**ADDENDUM NO. 1**

**BRANDYWINE SCHOOL DISTRICT  
CLAYMONT ELEMENTARY SCHOOL RENOVATION  
BID PAC B  
3401 Green Street, Claymont, DE 19703**

ABHA Architects, Inc.  
1621 N. Lincoln Street  
Wilmington, Delaware 19806

DRAWING A-515

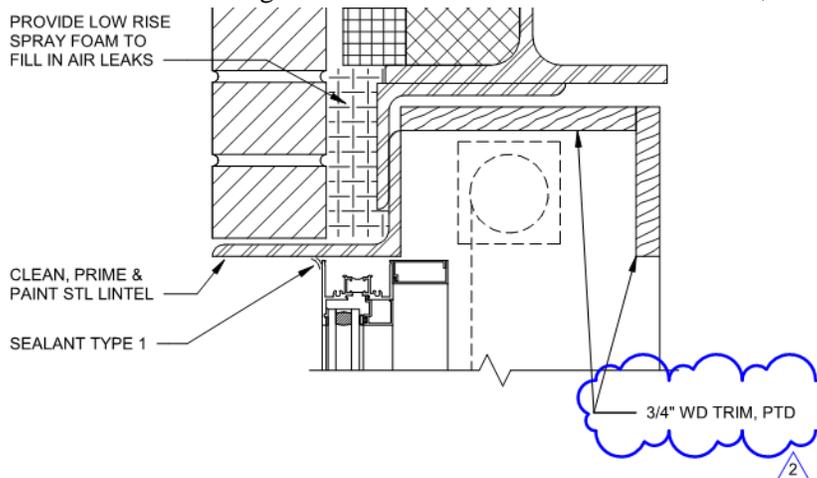
DELETE Drawing A-515 and REPLACE with Drawing A-515, dated 12/13/2018, attached to this Addendum.
